Application Type: **Site Plan**
Status: **First Referral**
Application Name: **Parker and Pine F1 L6 – Everbrook Daycare**
Case/AP#: **SP20-058**
Referral Received: January 29, 2021
Comments Due: February 23, 2021

Review date: **February 16, 2021**
Plan reviewer: **Randall L. Capra, rcapra@parkeronline.org**
Phone: 303.805.3169

TOWN OF PARKER FIRE/LIFE SAFETY:	C REVIEWED FOR CODE COMPLIANCE w/COMMENTS
---	--

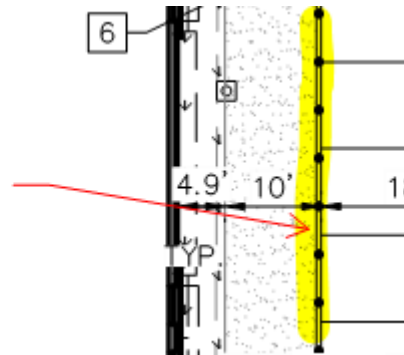
- A. *Please provide information as to what these symbols are on the site plan; should these be bollards and a fence, the improvements should be inset to allow vehicles to fully use the parking spots. Should there be a fence in this location, the question arises as to how parents and children will access the walkway without having to walk through a parking lot. Additionally, emergency access will be compromised should a fence be installed in this area. See below and address this issue when resubmitting: **Satisfied; applicant has addressed with current submittal noting that these are bollards. Bollards have been shifted in the sidewalk.***

What are these symbols? Provide information on this.

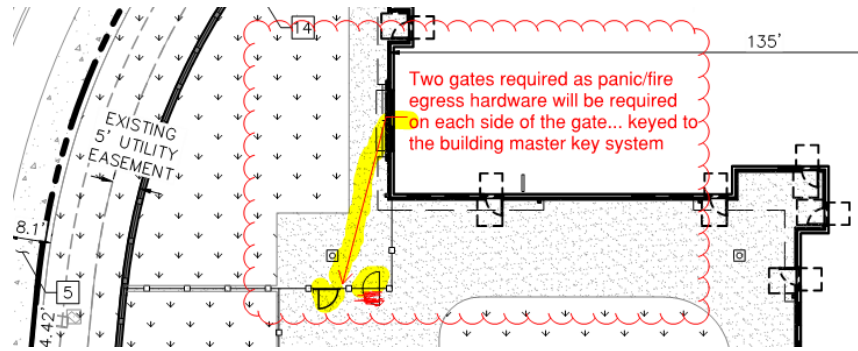
9. The playground areas shall be separated that each of the areas has two points of egress, separate by one half of the diagonal. Gates will be required to have panic/fire egress hardware and in each play yard, gates shall open in the direction of travel; this will require that two gates will be required when separating play yards to ensure that this provision is met. *Not satisfied; applicant has acknowledged with current submittal though intent does not*

meet code... see below: **Satisfied; applicant has addressed/acknowledged with current submittal indicating that the gates are to be installed as shown.**

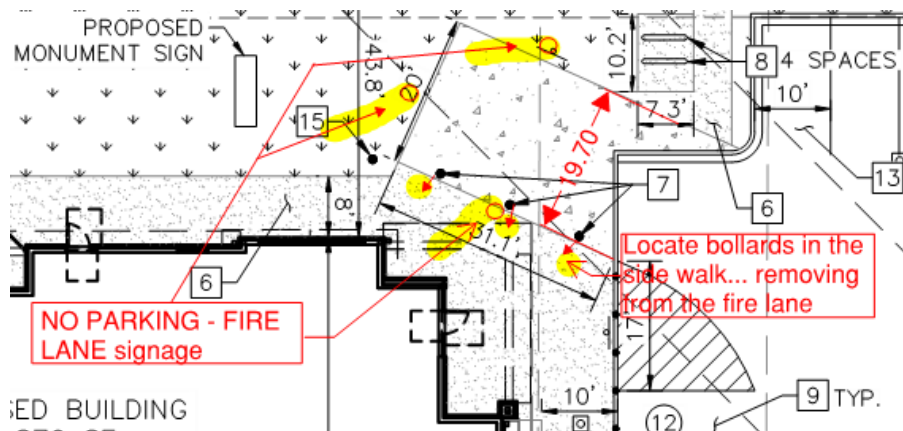
11. The construction drawings indicate that there are three proposed removable bollards to be placed at the hammer head required for site access; the applicant shall remove the bollards from the site plan as they are not allowed. Signage may be placed that states EMERGENCY ACCESS ONLY on each side of the entry. No Parking – Fire Lane signage (with directional arrows pointing either direction) shall be placed on all three sides of the hammerhead. See below for fire lane signage areas. **Partially satisfied; applicant has relocated the “removable” bollards though and placed adjacent to the access (Bldg side). The bollards, however, are shown in the 20-foot clear width of the required fire lane and shall be placed in the sidewalk outside of the 20-foot clear width requirement. See below for more direction and address this issue when resubmitting. Satisfied; applicant has addressed/acknowledged with current submittal indicating that the bollards have been located outside the required 20-foot clear area.**
